## Proposed Amendments to the Zoning Code Final Planning and Zoning Commission Recommendation

### Chapter 10-50: Supplemental to Zones

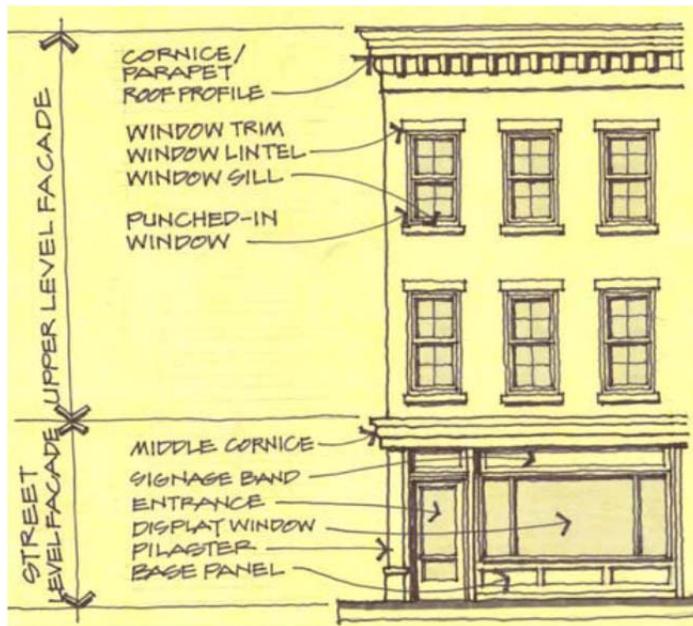
*Modify this drawing so that it is more appropriate in the context of Flagstaff OR include an appropriate photograph.*

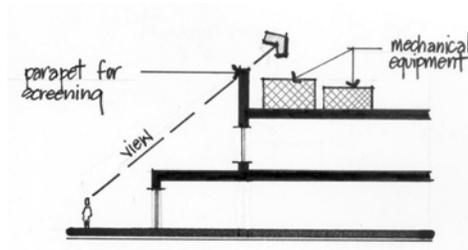
[Insert appropriate illustration like this one from the City of Sedona]

*(P&Z): This amendment requires that all rooftop mechanical and electrical equipment, and all ground mounted mechanical equipment, must be screened consistent with former language in the LDC. The language regarding screening of ground mounted electrical equipment has been removed.*

FIGURE A: LOCATION OF REQUIRED LANDSCAPE AREAS

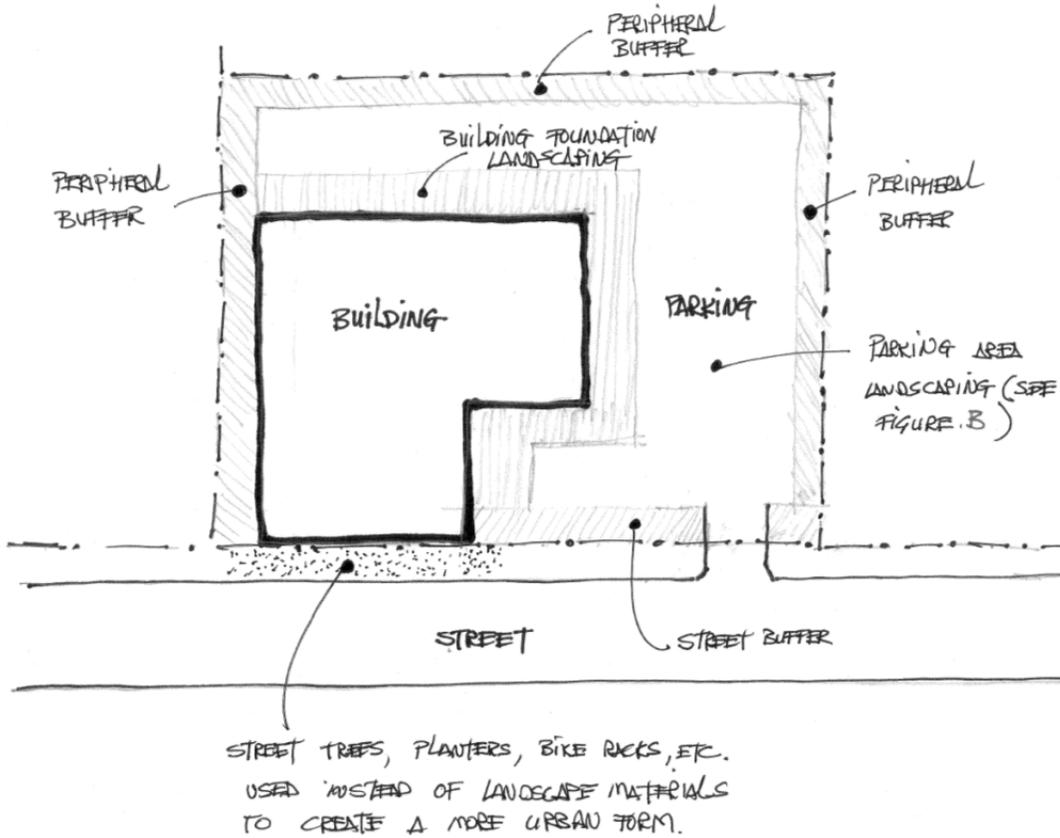
Note that existing Figure A: (Street Buffer) and Figure B: (Peripheral Buffer) will be deleted and a new Figure A: Location of Required Landscape Areas inserted.

FIGURE B. INTERIOR PARKING AREA - LANDSCAPE LOCATION REQUIREMENTS

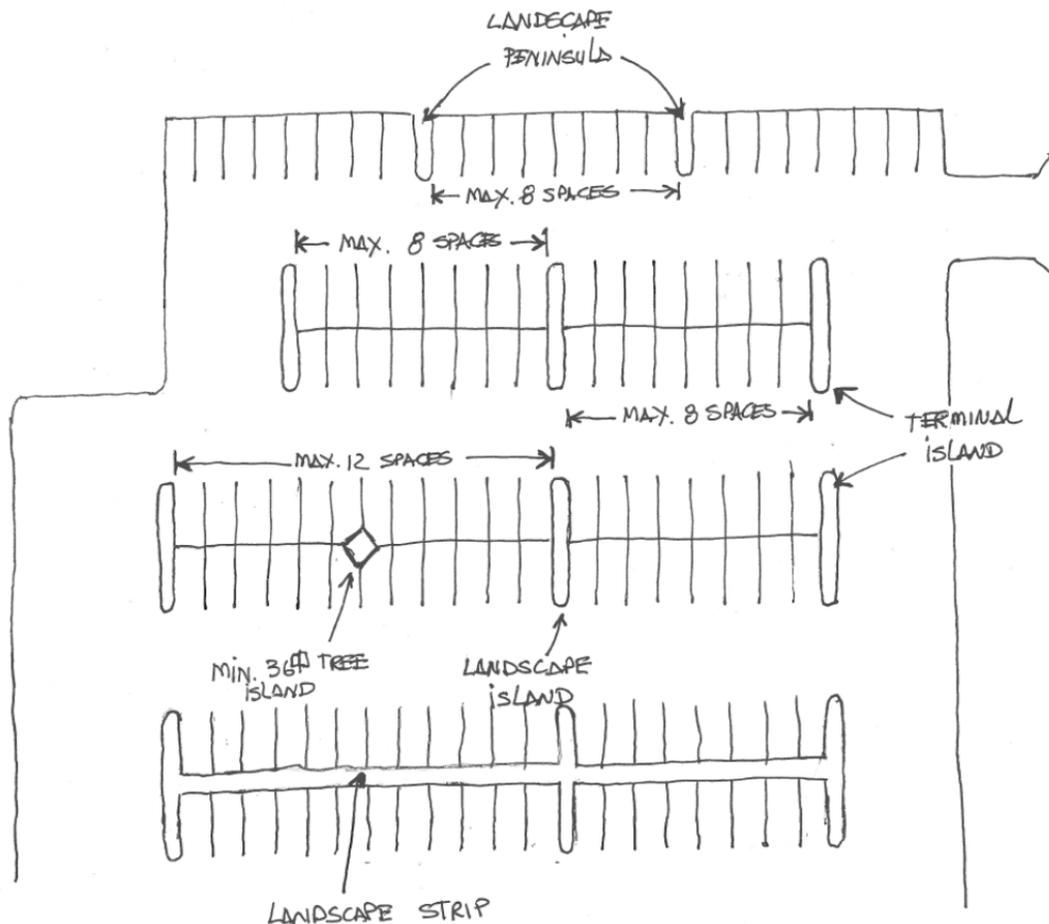
*Note that Figure B. (Interior Parking Area - Landscape Location Requirements) needs to be redrawn to better and more accurately illustrate the standards in the Section.*

For parking lots with eight or more spaces [aligned in a row](#), the required interior parking area landscaping shall be installed in islands separating adjacent parking spaces or in peninsulas parallel to individual parking spaces (see Figure [B](#)). [Up to 12 back-to-back spaces may be laid out in a row between islands or peninsulas if either a 36 square foot tree well is located midway between them or a landscape strip with a minimum width of five feet is installed between the rows of parking spaces \(see Figure B\).](#)

FIGURE C.

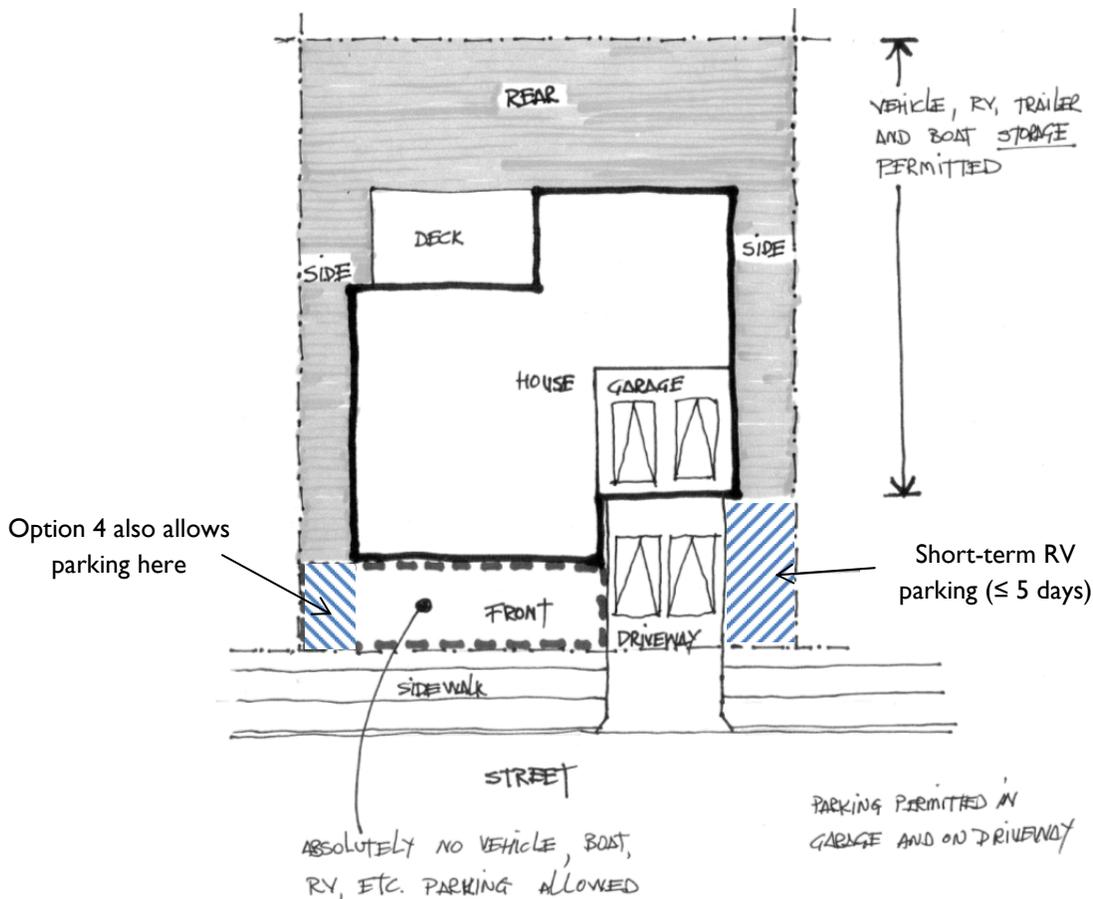
- b. Within residential zones, parking is permitted in interior and rear setback areas provided that such parking is screened by a min. six-foot high wall or fence- (see Section 10-50.50.020 (Siting and Building Standards), and within the front yard setback area only in front of a garages ~~or~~ carports, as well as on the side of the driveway between the driveway and the nearest property line in front of the ~~in interior side and rear~~ setback areas as illustrated in Figure C.

*Insert illustration – see next page.*

**At the June 24th public meeting the Commission moved to recommend that the Council should adopt this option. The Commission also recommended that if vehicles are parked in a rear or side yard area they should be screened from their neighbors by a six-foot high wall or fence.**

- Where parking is allowed under today's rules
- Where parking is proposed to be allowed OPTION 1
- Where parking is proposed to be allowed OPTION 2
- Another Alternative. Allow parking here? OPTION 3

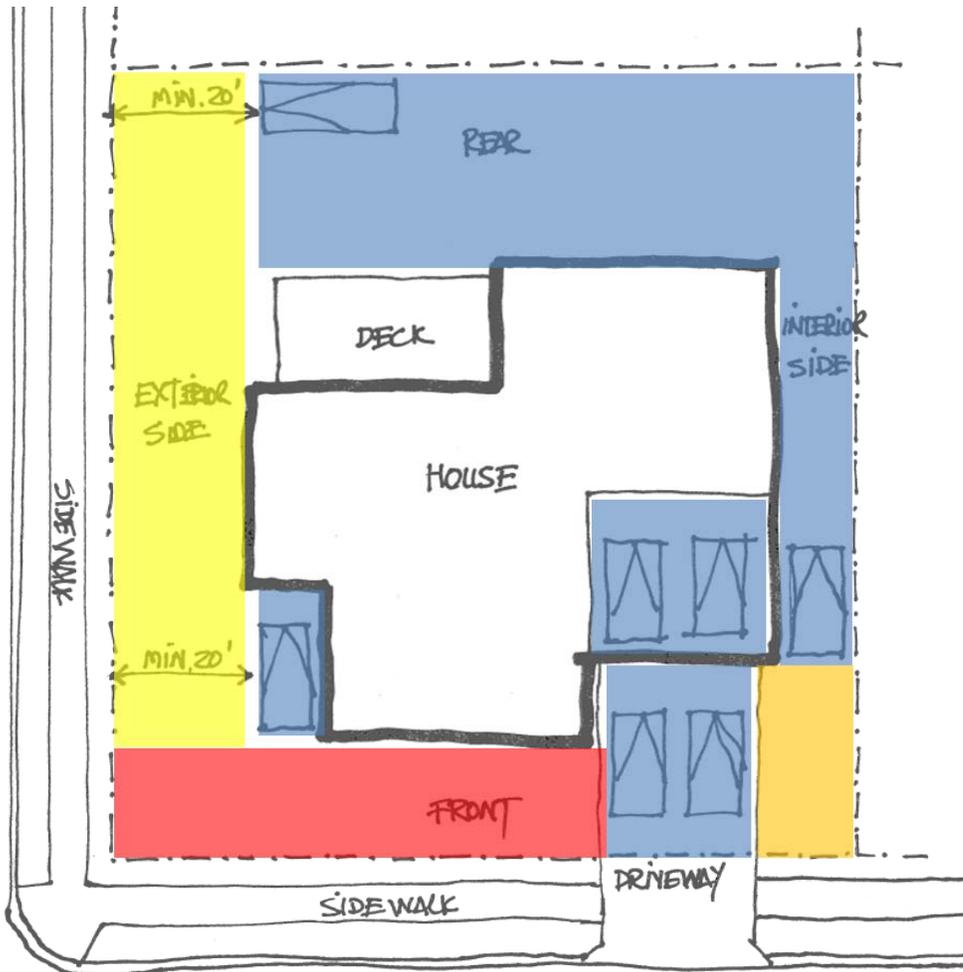
**OPTION 3:** A third option provides an alternative to also allow parking in the exterior side yard area – see illustration on the following page. The current Code only permits such parking (Paragraph 2.a above) if a vehicle is parked a minimum of 20 feet from the exterior side property line. This alternative would certainly provide many more off-street parking opportunities, but it will also inevitably be opposed by some residents. Subparagraph b would be written as follows if this option is accepted:

- b. Within residential zones, parking is permitted in any setback or yard area within the front yard setback in front of garages and carports as well as in interior and rear setback areas.
